DESIGN RECOMMENDATION MEETING

DPD PROJECT #3017251
2020 S. JACKSON ST.
SEATTLE, WA 98144
JACKSON WORKFORCE
HOUSING

FEBRUARY 25, 2015

CS1-B Sunlight and Natural Ventilation.

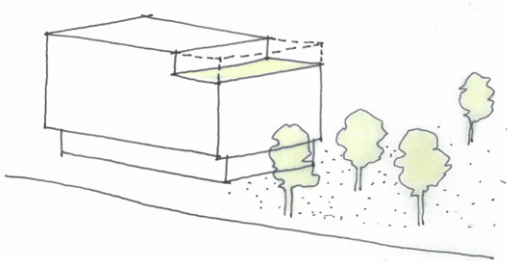
The Board recommended the project minimize shading on adjacent sites by providing additional relief at the alley via setbacks and/or modulation. The Board requested solar exposure studies, to be presented at the Recommendation Meeting, that illustrate the impacts of all schemes on the alley.

The upper residential floor mass overhangs to the south to maximize light and air across the alley to the north lowrise residences.

The alley façade has been revised so that the upper residential floors are set back a minimum of 13'-2" to 14'-8" from the alley. The proposed setback enhances the alley by providing additional area for ground level landscaping, while reducing the building shadow on the properties to the north. The upper mass at the east has also been eroded to locate a roof deck on level 7. This change further reduces the amount of building shadow to the north. Modulation at the upper floors and base of the building, in material texture, color, and landscaping breaks up an otherwise long monotonous façade into smaller, interesting segments. Please also refer to the sun/shadow studies of the updated scheme are included in this packet.

CS1-D Plants and Habitat.

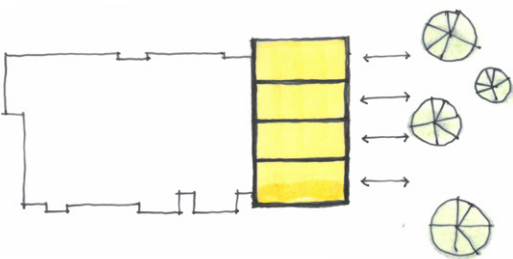
The Board recommended further development of the programming and design to better relate to the park and provide opportunities for interaction through use of windows, active uses, modulation, and/or materials to better respond to the park. The Board requested three highly detailed massing options (including perspectives) be presented at the Recommendation Meeting.

Responding to the park at the scale of the neighborhood, the building's upper mass at the east has been eroded to locate a roof deck on level 7. This setback responds to the park visually and programmatically. Visually, the roof deck canopy relates to the main entry canopy and looks towards the park in the east. Programmatically, the common roof deck is oriented towards the park.

At the east building base, four residential townhouse units have been introduced that are oriented to the park instead of S. Jackson Street. The modulation and treatment of the townhouse entries, patios, and large windows emphasize this portion of the façade as the front of these units. The large patios and secondary walkway element allow for residential access and introduce activity along the east portion of the site.

CS2-B Adjacent Sites, Streets, and Open Spaces.

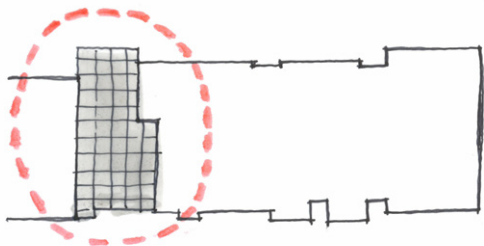
The Board supported a strong building edge along South Jackson Street, finding this to be an appropriate response to the neighborhood. At the west end of the site, a courtyard is proposed at the residential lobby entrance; the Board agreed this courtyard creates a strong connection to the public realm by providing opportunity for resident interaction.

The Board emphasized the importance of the connection to the adjacent park to the east, and recommended further development of façade composition, articulation, high quality building materials, programming, and/or entrances to further express the connection to the park. The Board requested that perspective drawings showing this relationship be presented at the Recommendation Meeting.

The shared courtyard will feature spaces to sit and people watch. The existing courtyard details such as paver types, plantings, planters and railings will be continued into the new courtyard. Detailed perspectives of the shared courtyard have been provided.

The relationship of the building to the park is shown in perspectives included in this packet. The townhouse entries are articulated in a similar manner to the main building entry and live/work entries at the south façade. This provides a unifying element between the facades, while creating more of a corner condition than shown at the EDG Meeting. The secondary, townhouse entries and shared patios provide a place for activity and small-scale interaction overlooking the park.

DC3-C Design.

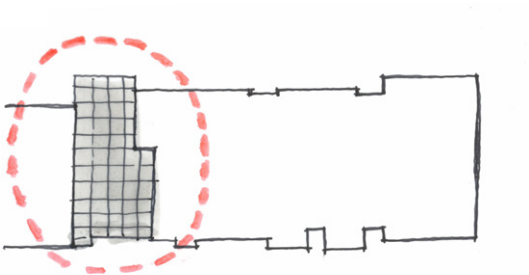
The Board agreed that the existing context creates opportunity for a strong open space concept. The Board agreed the courtyard at the west end of the site reinforces and enhances the existing courtyard on the property to the west. The Board agreed the combination of these two courtyards will provide opportunity for attractive outdoor space suited to the residents of both buildings.

As previously stated in CS2-B, the shared courtyard will feature spaces to sit and people watch. The existing courtyard treatment such as paver types, plantings, planters and railings will be continued into the new courtyard. Detailed perspectives of the shared courtyard have been provided.

DC4-D Trees, Landscape, and Hardscape Materials.

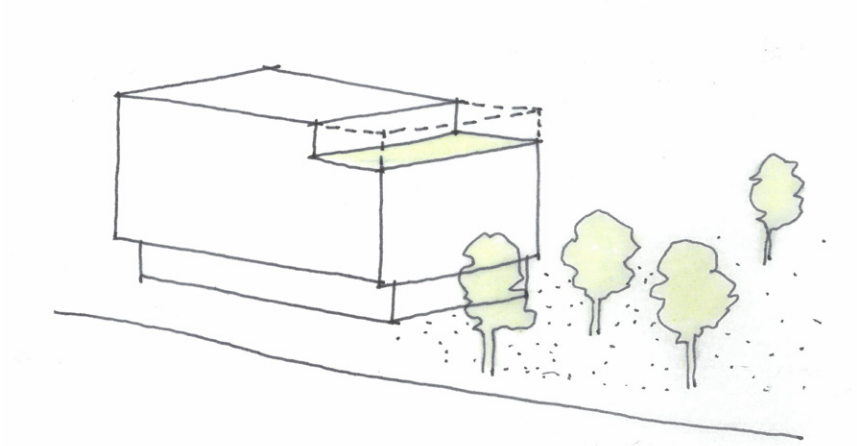
The Board agreed that the courtyard is best located at the residential lobby, and recommended the use of high quality materials and landscape to enliven this open space. The Board recommended the use of high quality elements and finishes for the building and its open space at all facades. The Board requested detailed elevations of each façade be presented at the Recommendation Meeting.

Hardscape in a checkerboard pattern matches the existing portion of the shared courtyard. Additional landscaping to the south softens the edges of the courtyard and provides a transition to the sidewalk. Smaller pots in the south entry plaza allow for more hardscape, appropriate to an urban environment, while the landscaping at the live -work units and residential portions of the building serve to provide interest and screening at the lower levels. Both the live-work units and townhouse patios share a similar paving treatment to emphasize them as different from the main building entrance. Elevations of the facades have been provided.

OPTION 1

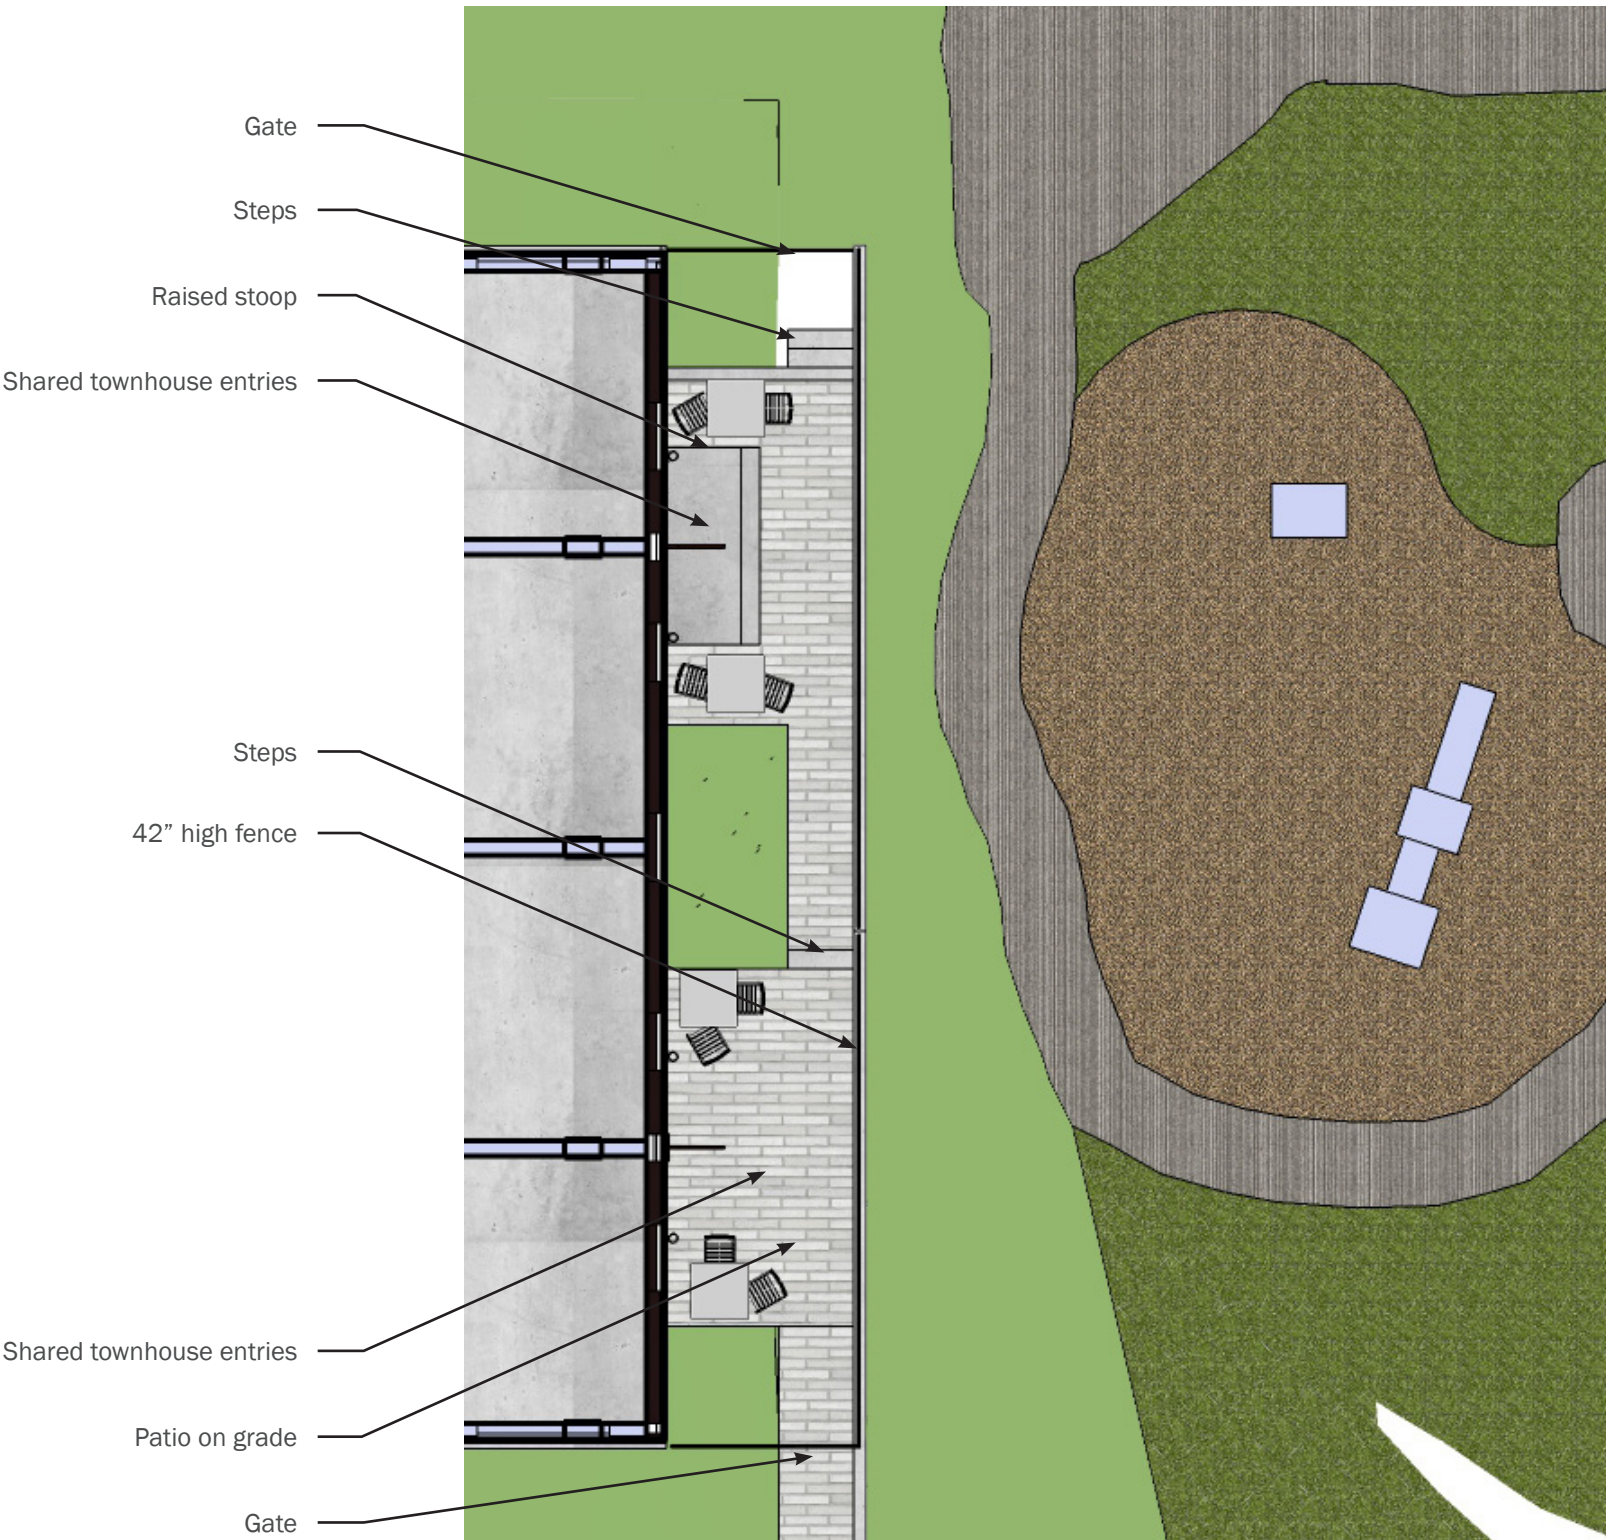
The Board emphasized the importance of the interface of the project with the park. The Board is concerned that the options presented do not provide an adequate response to the park, and recommend further development and consideration of programming, modulation, setbacks, and high quality materials that respond to the open space condition. The Board noted that this site, with its proximity to the park, acts as a corner site, and provides opportunity to treat the southeast corner as such. The Board encouraged consideration of angling the entrance at this corner. The Board requested the following information be presented at the Recommendation Meeting: three new distinctive, highly detailed options that showcase a strong connection with the park. Perspectives shall also be presented.

Three options are shown for the building response to the park on the east. Option 1 includes orienting 4 townhouses to the park.

Since this option was studied, the roof deck has been relocated to Level 7 (option 2 and 3), significantly improving the overall massing to the east and alley, as well as providing another opportunity for residents to engage with the park.

Option 1 introduces raised stoops at the 2 northernmost townhouses, which is not ideal. It limits the resident's use of the outdoor space and potentially limits the opportunity to activate the outdoor space adjacent to the park. Due to the height limit, significant grade change, and the accessibility of the units, the southernmost townhouses cannot be raised to provide a stoop condition.
